MEMORANDUM CH2MHILL

# Review Comments on On-Site Soils RI/FS Work Plan Addendum No. 2 Scope of Work for Additional Investigation, Omega Chemical Superfund Site, April 8, 2005

April 15, 2005

Figure 23 Location of Proposed Soil Vapor Samples

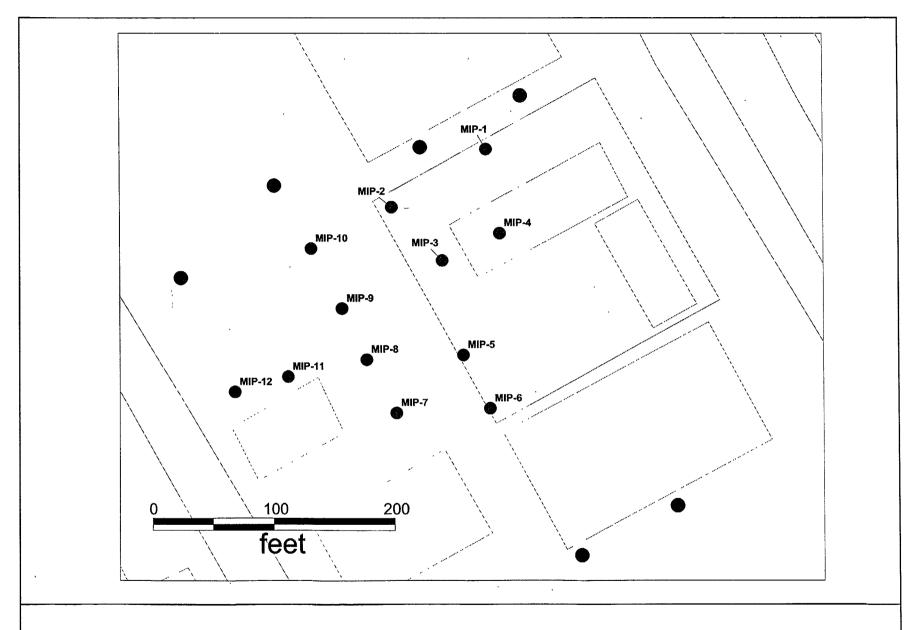
- 12. <u>Section 4.0 Proposed Scope of Work and Procedures</u>: Page 8, 3<sup>rd</sup> par. Discuss MP-7 to MP-12, their rationale, etc.
- 13. Section 4.0 Proposed Scope of Work and Procedures: Additional soil gas and MIP sampling locations are required as shown in Attachment 2. Two of these locations correspond to SG 13 and SG-14 where contaminant vapors were detected at 6 and 12 feet below ground surface. The soil-gas sampling depths at these locations should be 18-70 feet. MIP and possibly hydropunch (HP) sampling (depending on the MIP results) should also be performed at these two locations. Three soil gas and two MIP (and possibly HP) sampling locations are required along the property boundary with Medlin and Sons where high PCE and Freon 11 concentrations were detected in historical shallow soil gas samples. Three additional MIP (and possibly HP) samples are between the Terra Pave and Bishop Co. buildings, north of MIP-11, and north of MIP-1. Soil samples should also be analyzed for density, porosity, moisture content, organic carbon, etc. besides the planned analysis for VOCs. Further off-property

- sampling locations will depend on the results for the samples currently shown. The Work Plan should include a rationale for the placement of additional off-property sampling locations and criteria for no further sampling.
- 14. <u>Section 5.0 Data Quality Objectives</u>: Page 10, 1st par. The extent of contamination has to be defined prior to the decisions regarding remediation. The 2003 Final Work Plan (Sections 1 and 7) state that one of the objectives of the RI/FS is to estimate the extent and nature of the contaminants.
